Rezoning Application: PD 26-0528

**Hillsborough
County Florida**

GENERAL DEVELOPMENT PLAN - PD 26-0528

HACIENDA WEST AT WIMAUMA
5902 BASSA ST.
WIMAUMA, HILLSBOROUGH COUNTY, FLORIDA 33598

SHEET NUMBER:
GDP-1

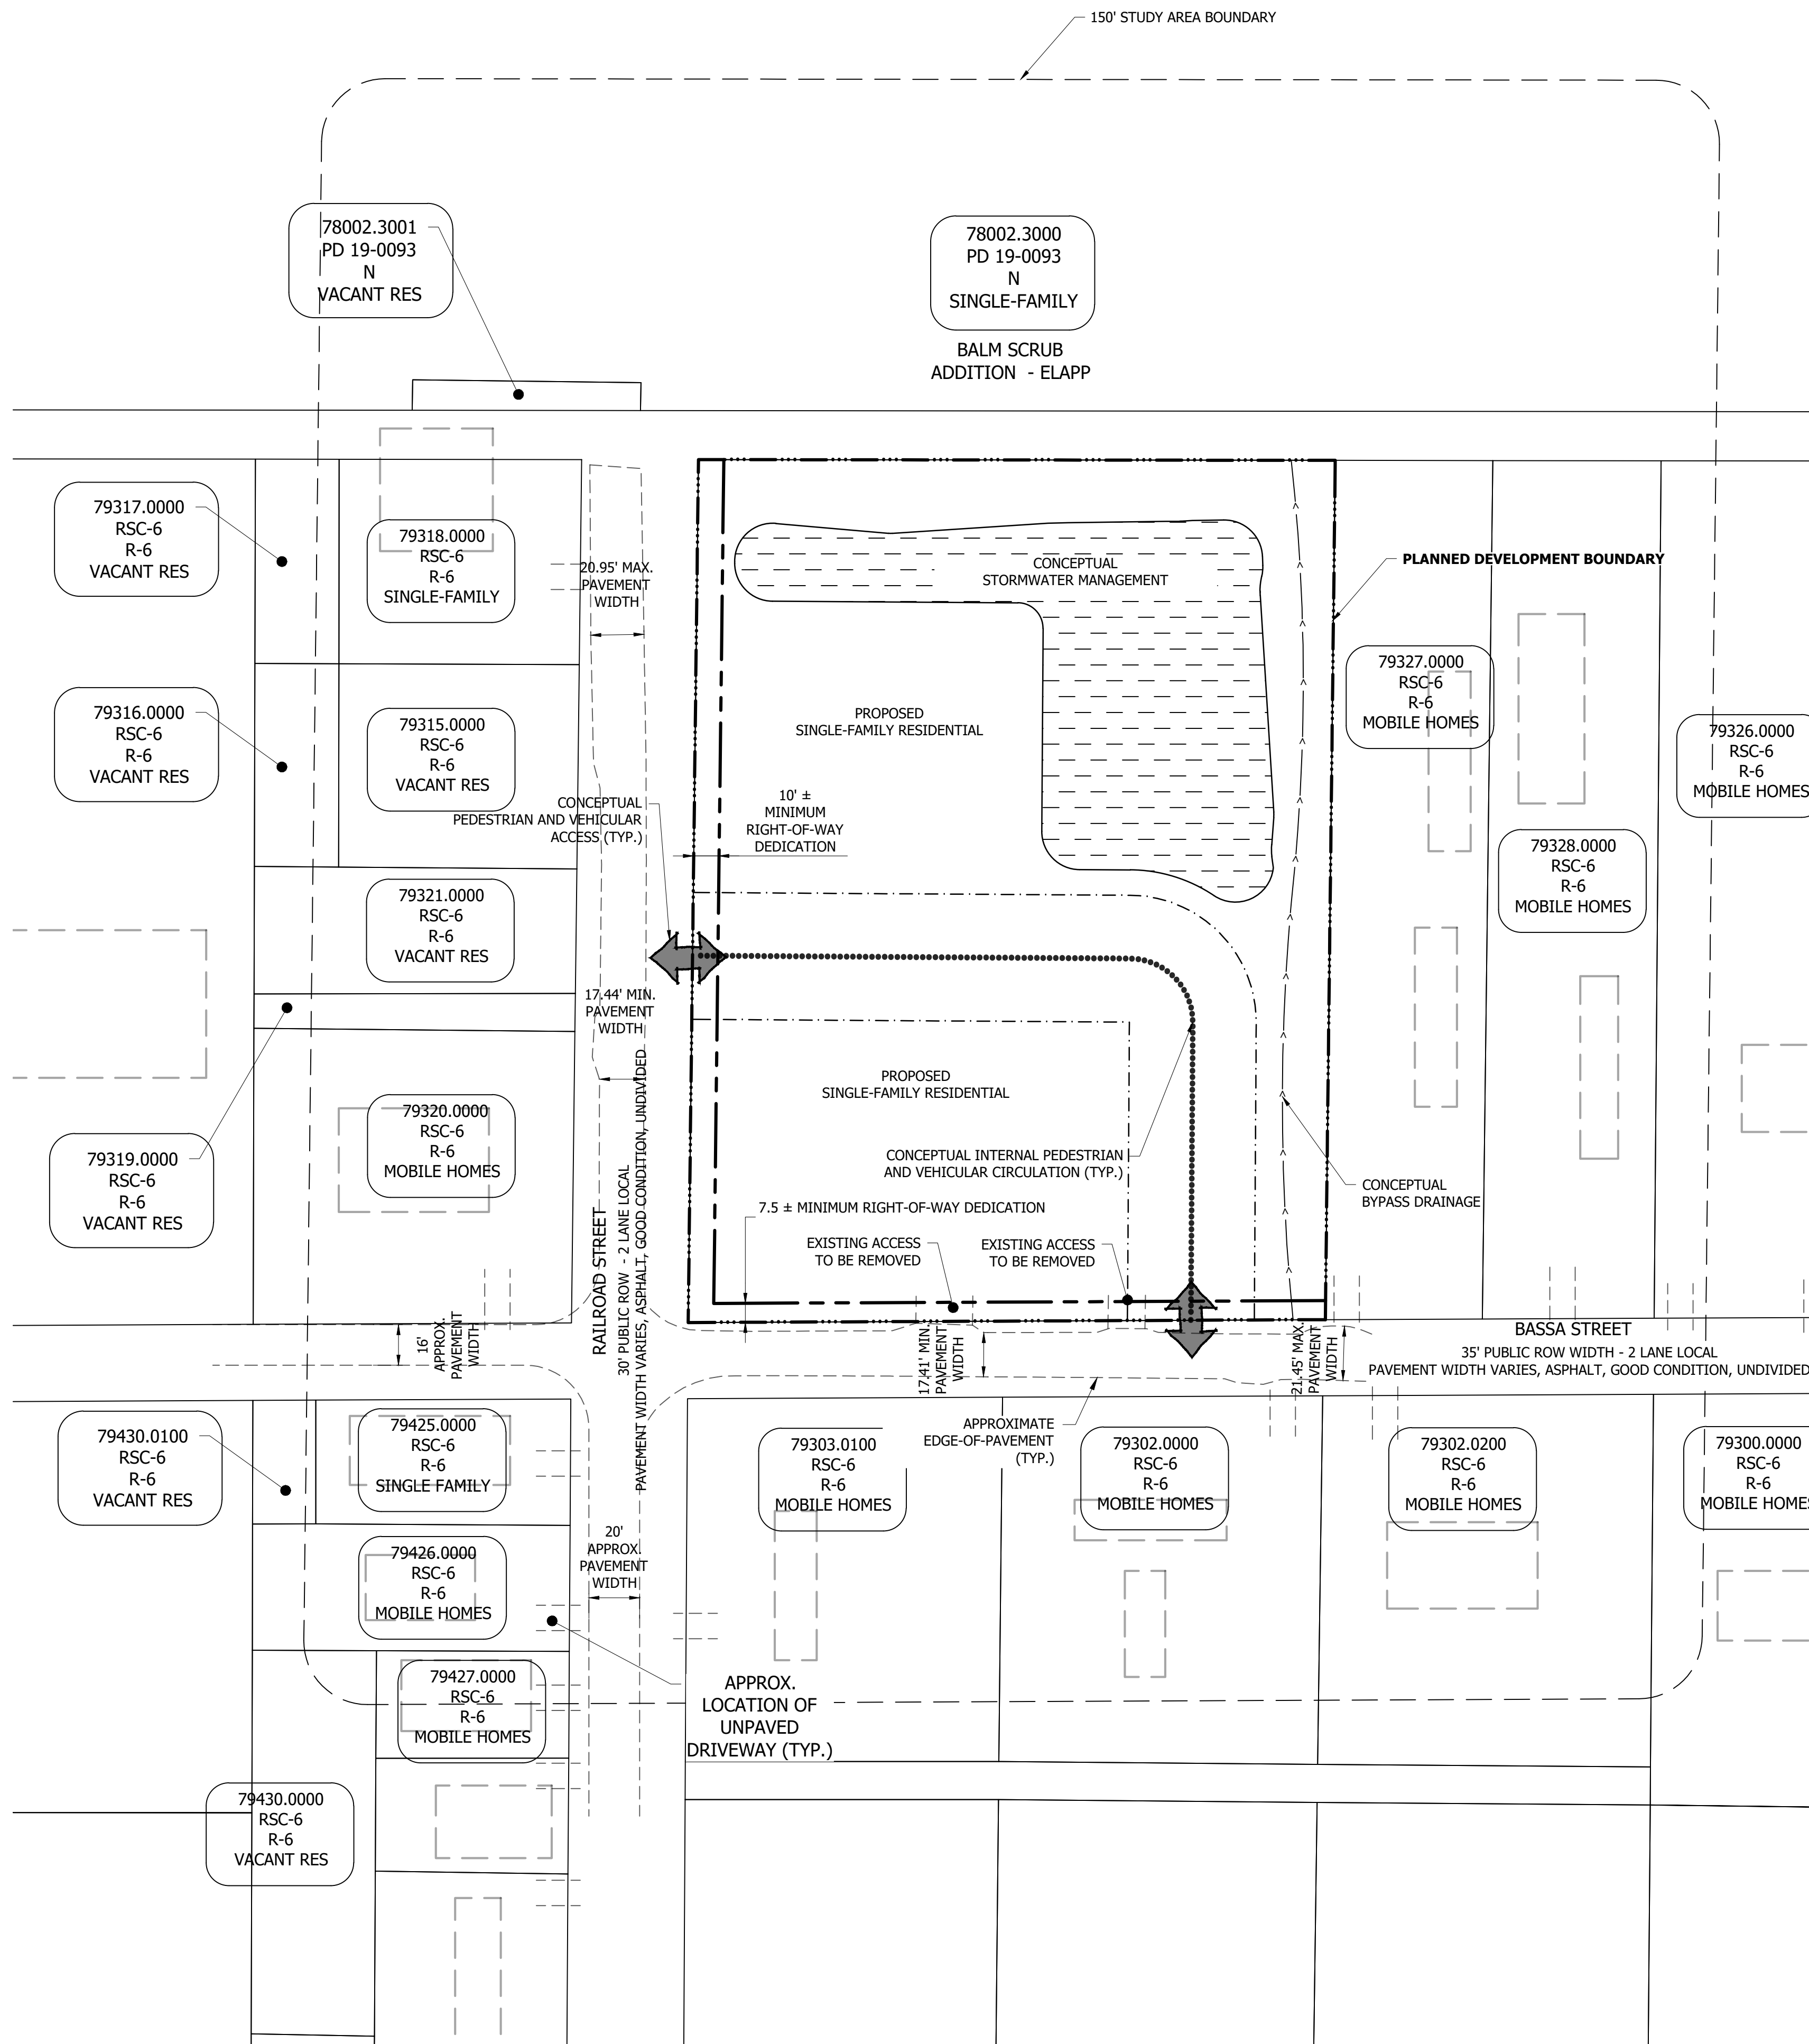
Prior to certification the following changes shall be made to the site plan:

- 1. Remove the minimum building envelope standard from the Site Data table.
